CITY OF ALBUQUERQUE

Re: Sunport Apartments
2930 Mulberry SE
Traffic Circulation Layout
Architect's Stamp 06-24-2020 (M15-D036)

SUNPORT APARTMENTS
SITE PLAN
ALBUQUERQUE, NM
2930 MULBERRY S.E.
PROJECT #1844

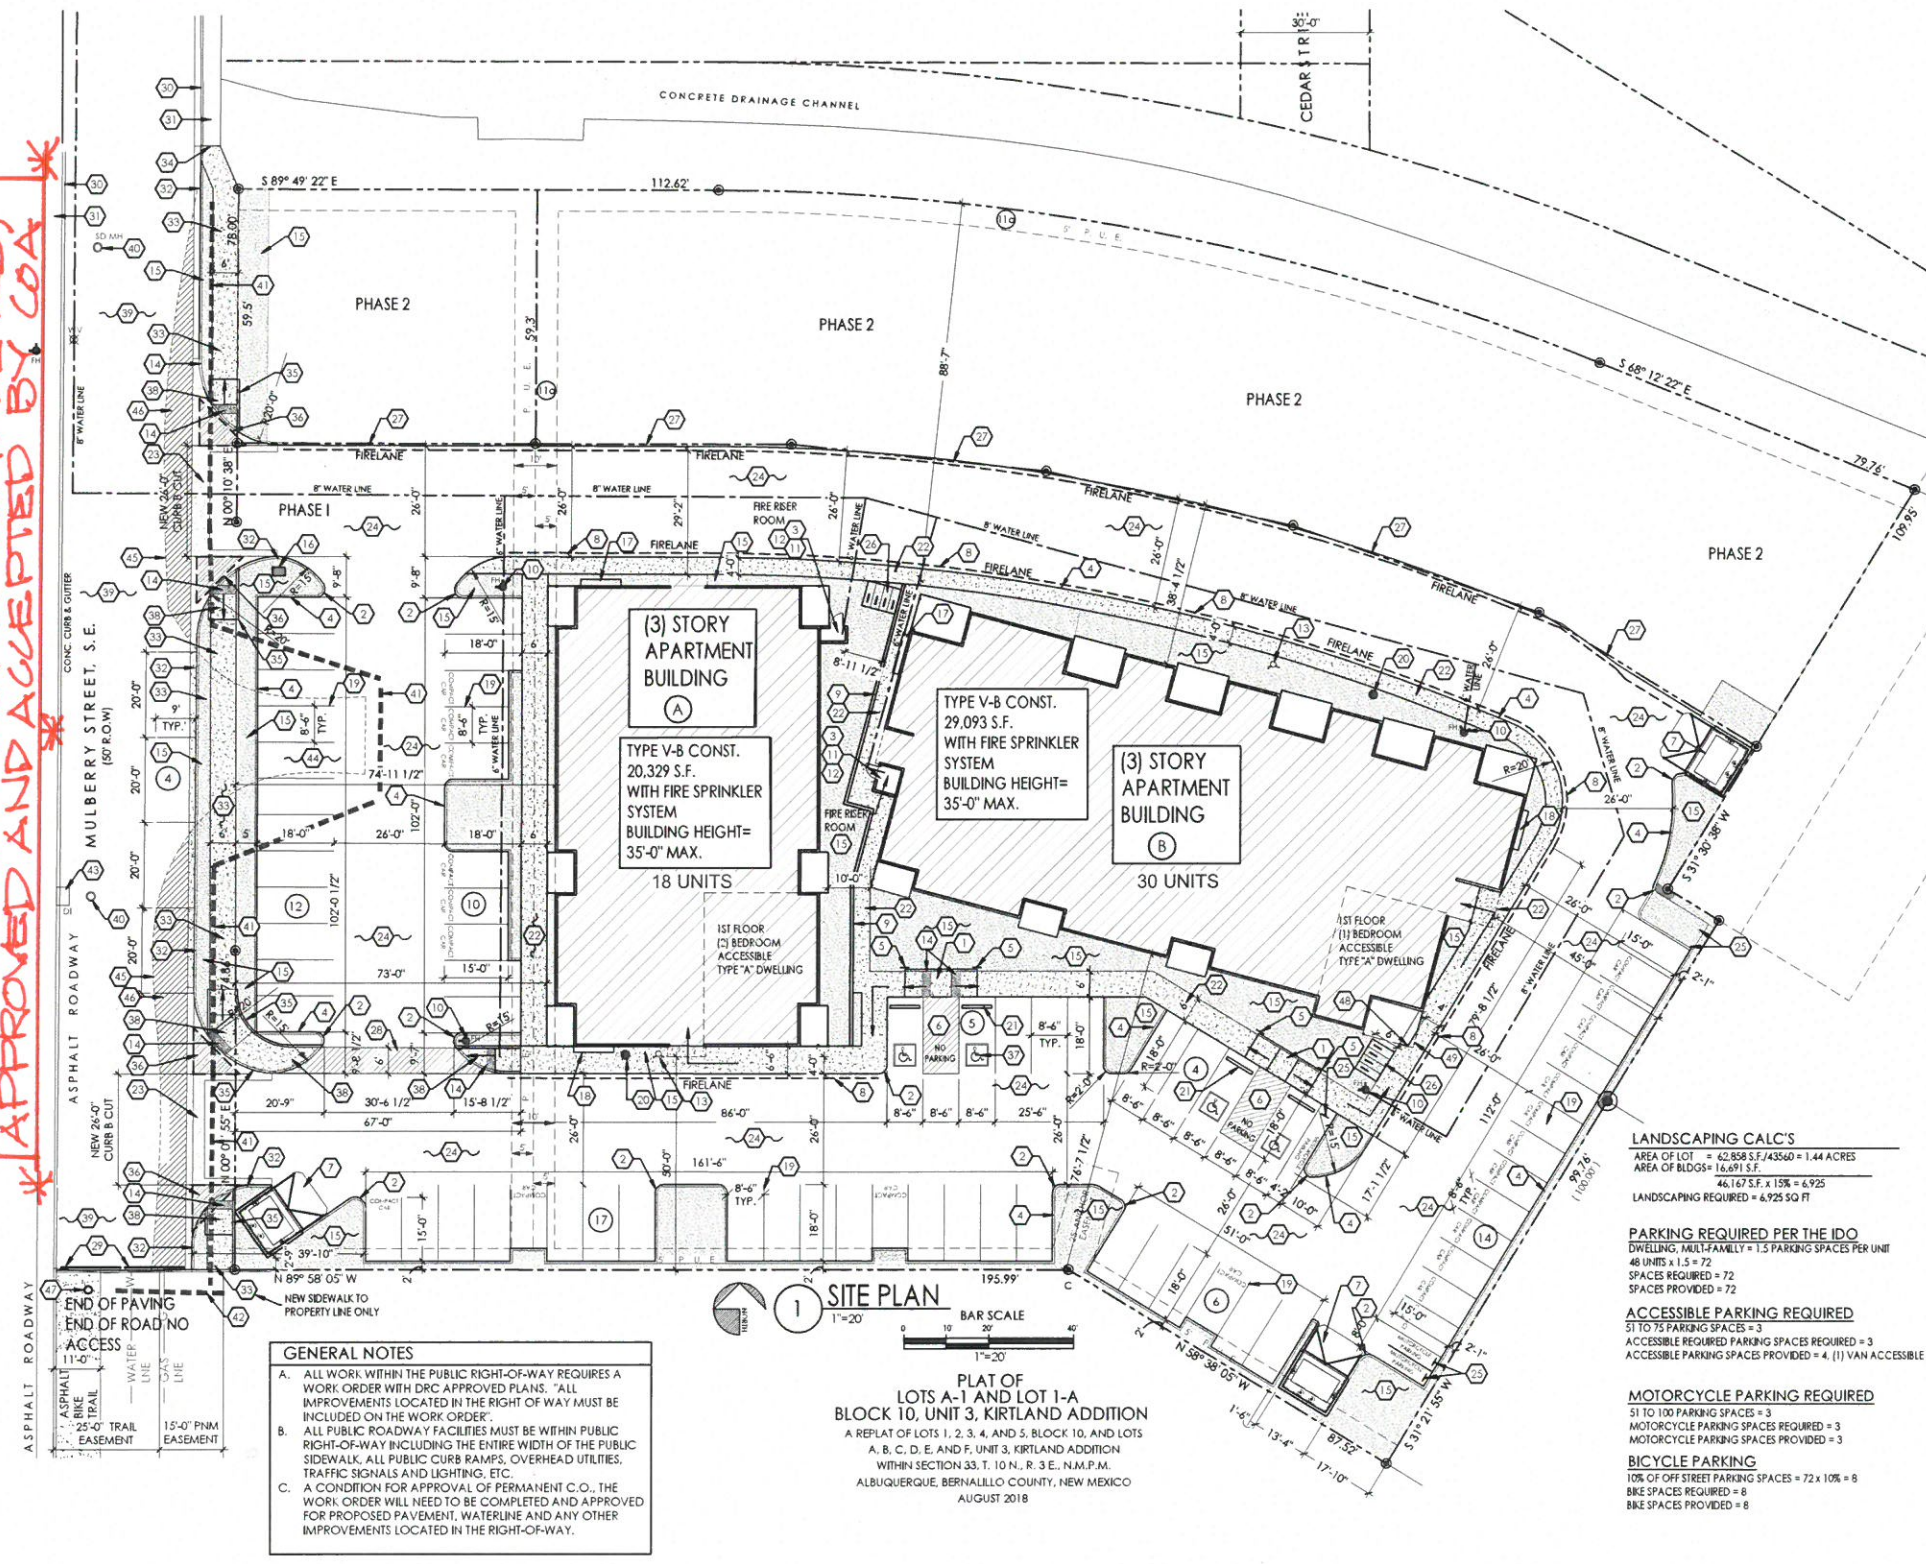
ALL WHEELCHAIR RAMPS LOCATED WITHIN THE PUBLIC RIGHT OF WAY MUST HAVE TRUNCATED DOMES.

CONDITION OF FINAL C.O.A. APPROVAL: WORK ORDER MUST BE COMPLETED, APPROVED AND ACCEPTED BY C.O.A.

SUNPORT APARTMENTS
SITE DETAILS
ALBUQUERQUE, NM
PROJECT #1844

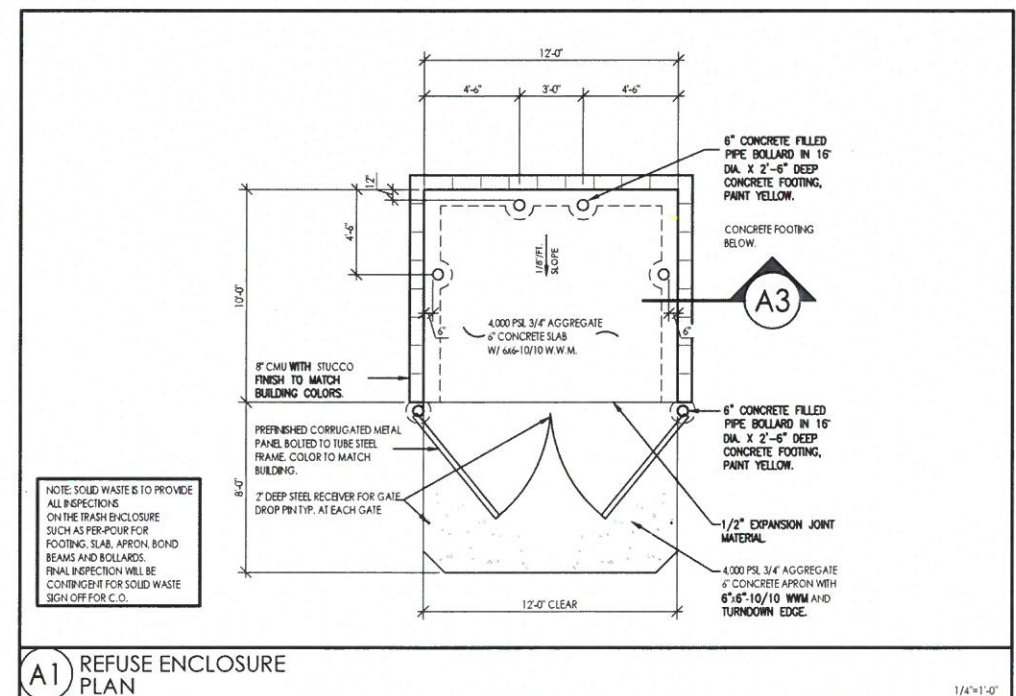
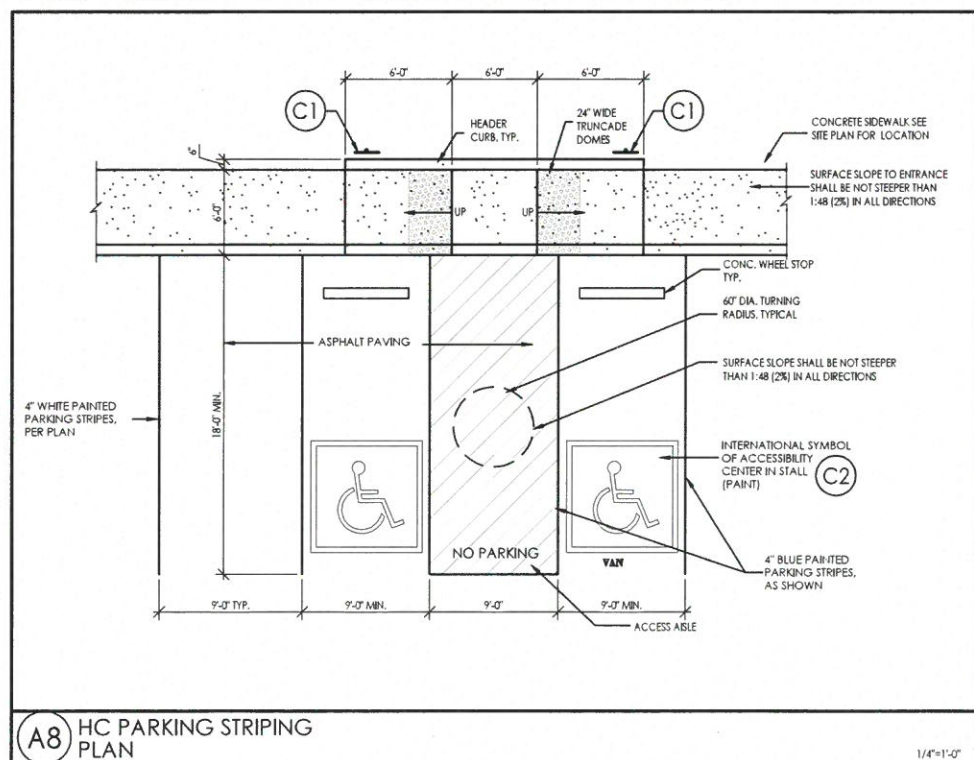
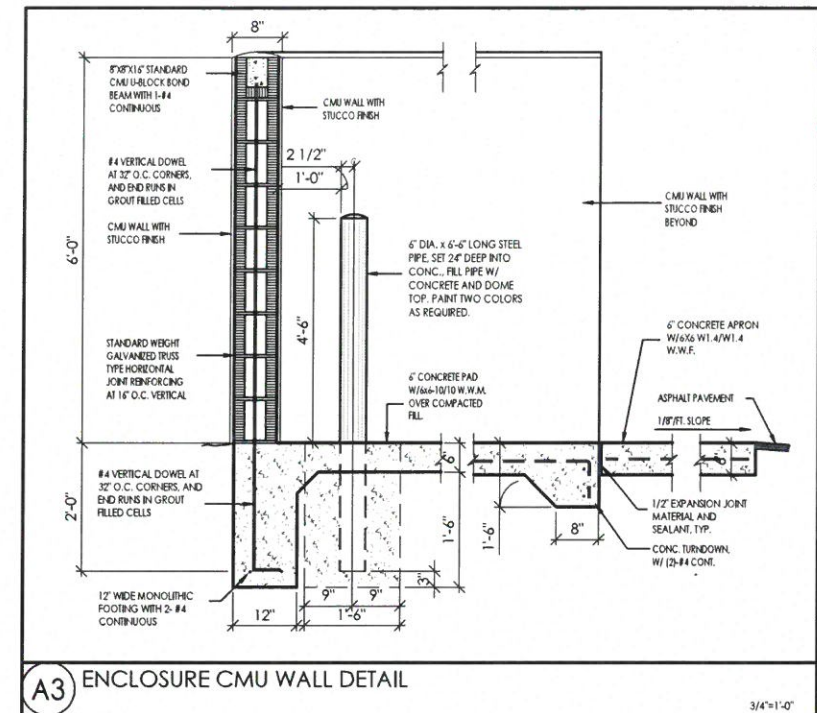
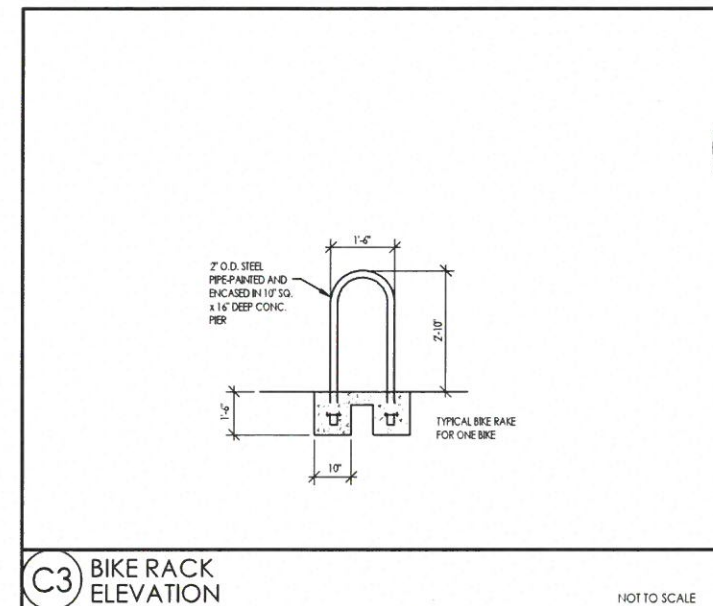
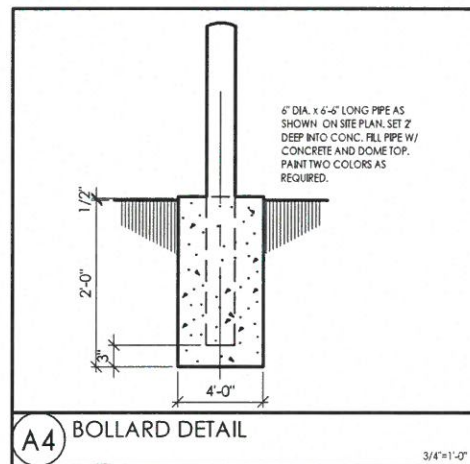
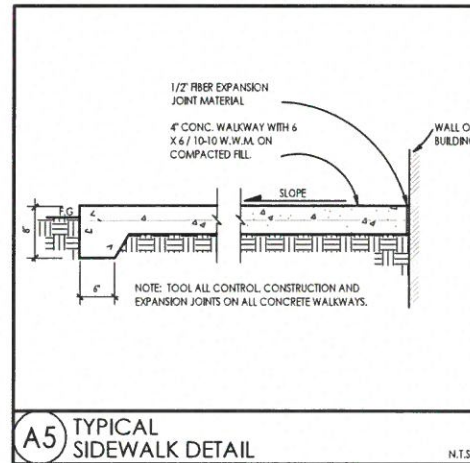
ALL WHEELCHAIR RAMPS LOCATED WITHIN THE PUBLIC RIGHT OF WAY MUST HAVE TRUNCATED DOMES.
